## PWYLLGOR CYNLLUNIO - DYDD IAU, 18FED AWST, 2022

**ATODIAD  
ADDENDUM**

**Adroddiad Pennaeth Lle a  
Chynaliadwyedd  
Adran yr Amgylchedd**

**Report of the Head of Place  
and Sustainability  
Environment Department**

# PL/00832 Visibility Splay Plan

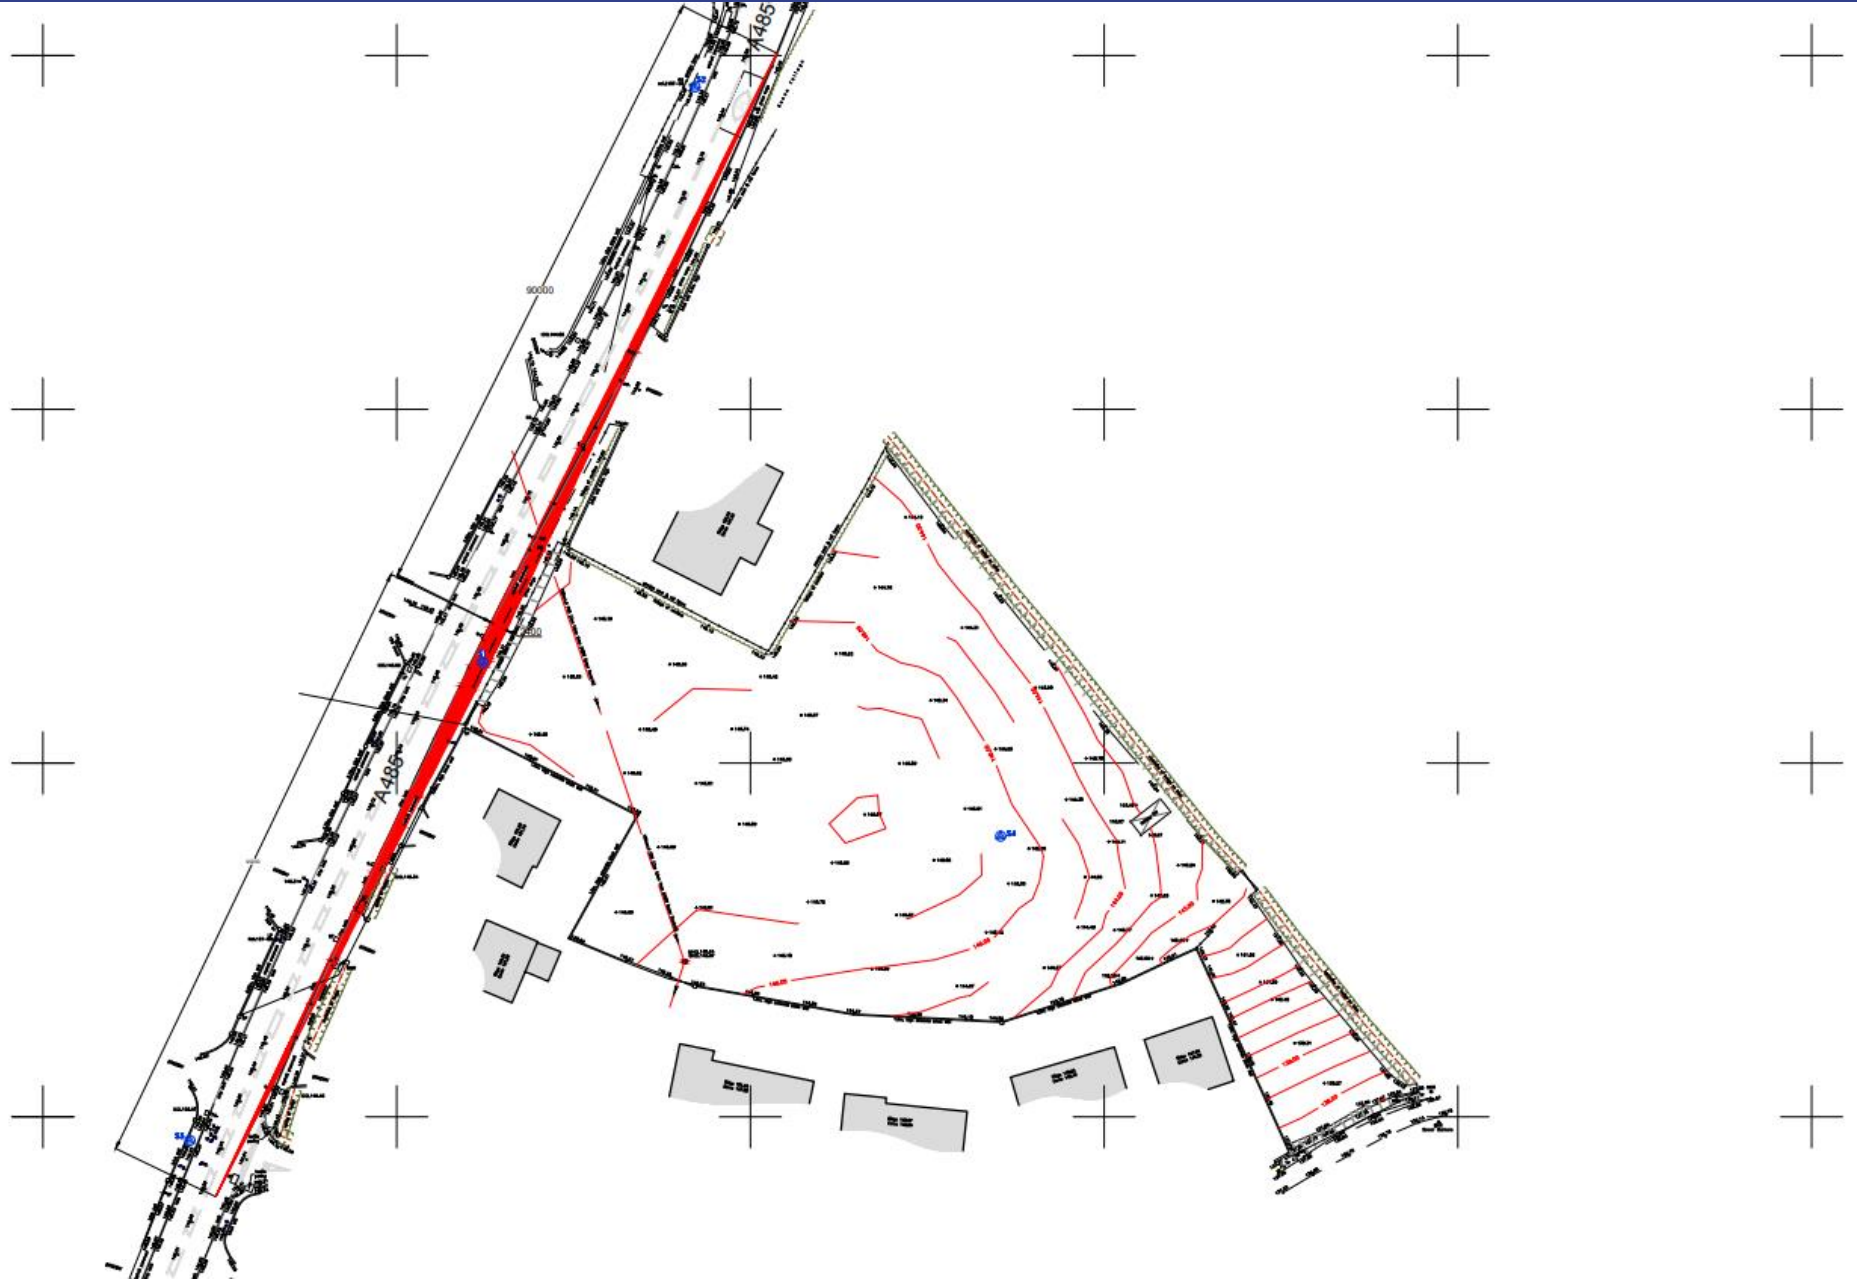
The following planning condition has been amended to a “Grampian” form of condition.

None of the development hereby granted planning permission shall commence until the proposed new vehicular access road is formed, comprising of a visibility splay of 2.4 metres x 90 metres in both directions and thereafter retained in perpetuity, either side of the centre line of the access in relation to the nearer edge of carriageway. There shall at no time be any obstruction above 0.9 metres within this splay area.
